Official Transcript of Proceedings
NUCLEAR REGULATORY COMMISSION

Title: Advisory Committee on Reactor Safeguards
Westinghouse AP1000 DCD

Date: Tuesday, August 16, 2011

MEETING OF THE SUBCOMMITTEE ON THE WESTINGHOUSE

Shield Building Roof DCD Figure 3H.5-11 Sheet 5

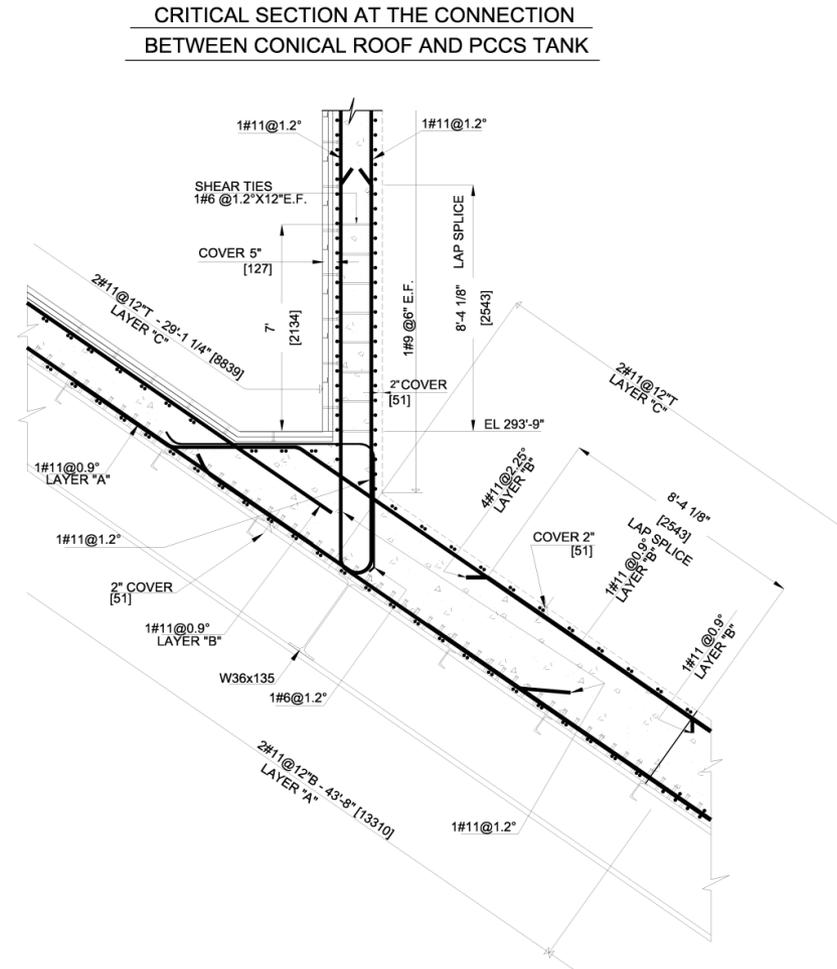
Figure 3H.5-11 Sheet 5 shows the knuckle region and a portion of the exterior wall. It is consistent with the reinforcement design defined in Table 3H.5-9 Sheet 3

Shield Building Roof DCD Figure 3H.5-11 Sheet 6

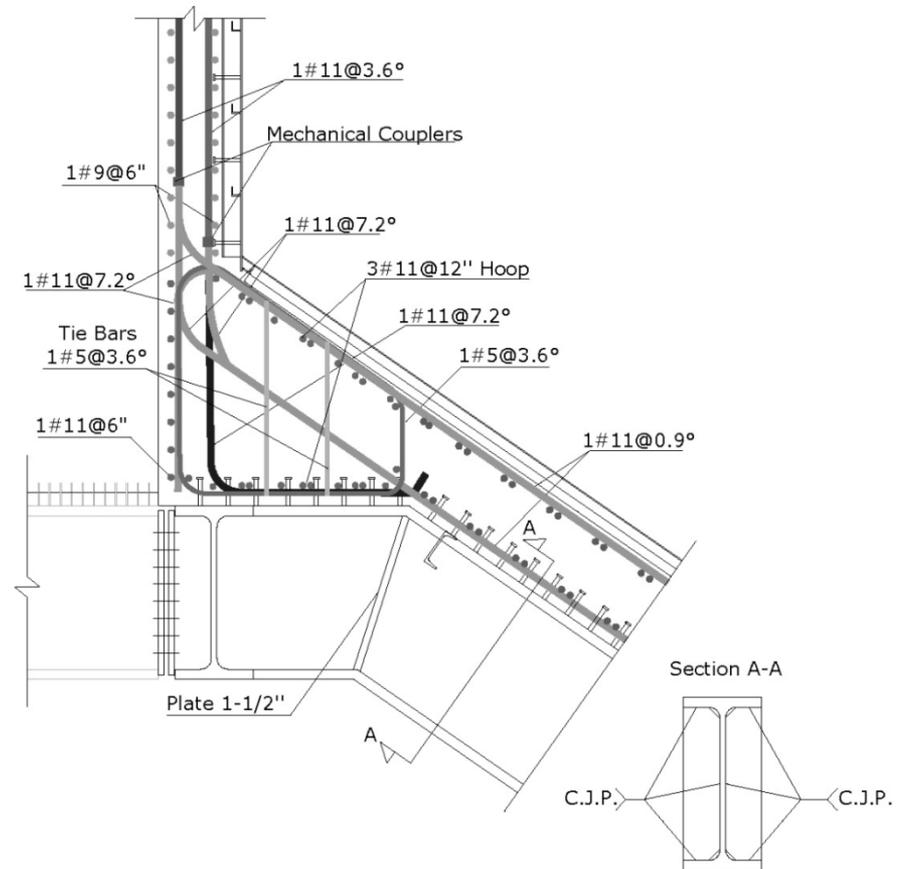
Figure 3H.5-11 Sheet 6
was added to show
reinforcement design of
compression ring

Containment Peak Pressure Analysis Input Update Summary

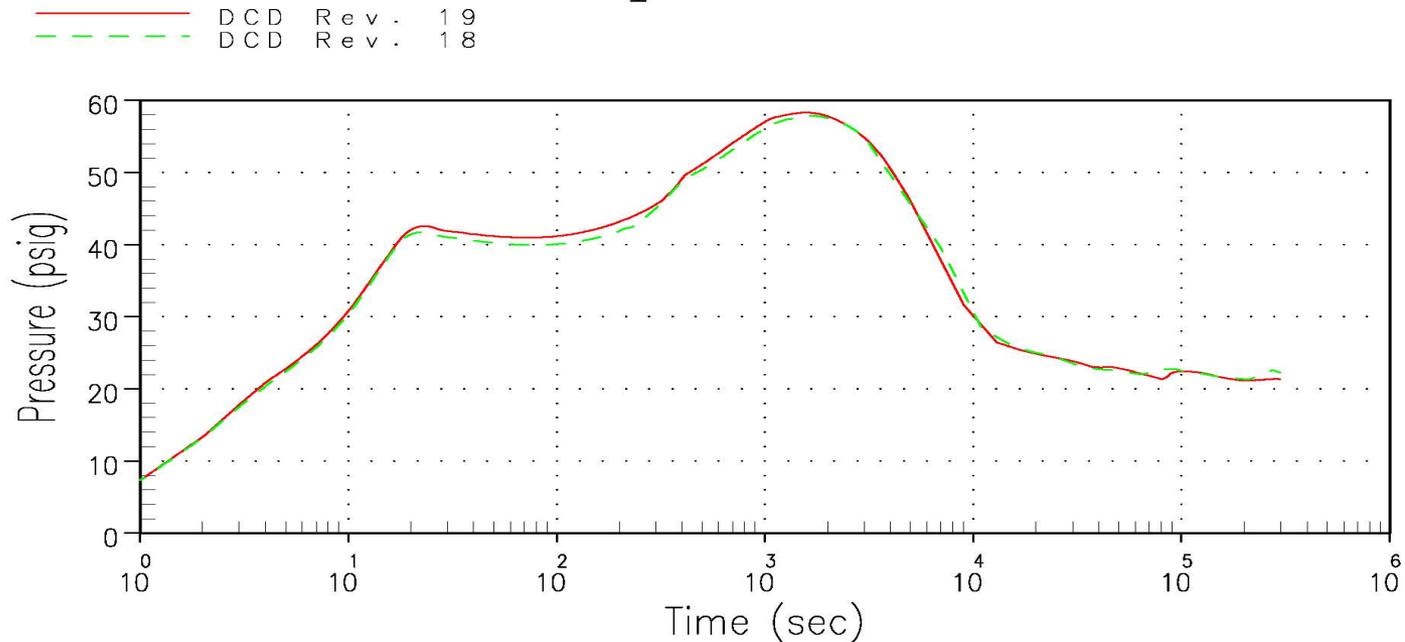
- Additional input changes were made to the models for the DCD Revision 19 containment analyses
 - Majority of items previously identified and captured in the Westinghouse corrective actions program
 - Impact of individual items on peak pressure is small and were intended to be addressed in future analyses, but have been incorporated in DCD Revision 19 at NRC request
 - 7 input changes in the LOCA mass and energy model (combined impact of all 7 is +0.8 psi)
 - 5 input changes in the containment response model (combined impact of all 5 is +0.3 psi)
 - Credited additional heat sinks in the containment response model (impact is -0.9 psi)

Figure 6-6: Large Scale Test Facility

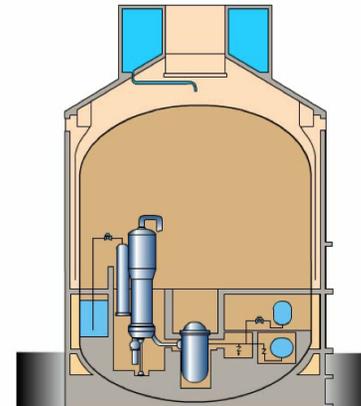
21 I recall I said that it's a question that
22 has been brought to us not only in the context of
23 induced stresses on the shield building, but in the
24 context of potential effect on the large-scale test
25 that was conducted under circumstances in which

3 Have you had any chance to think about
4 that or provide any comment? You're not obligated to
5 do so at this point.

6 MR. CARPENTER: Okay. So, our response
7 would be that the heat and mass transfer data taken
8 from the testing is lower bounded when applied to the
9 evaluation model. And the test data was taken from
10 several different facilities, test facilities and on
11 different scales. So, not all the test data was
12 exposed to sunlight and outdoors.
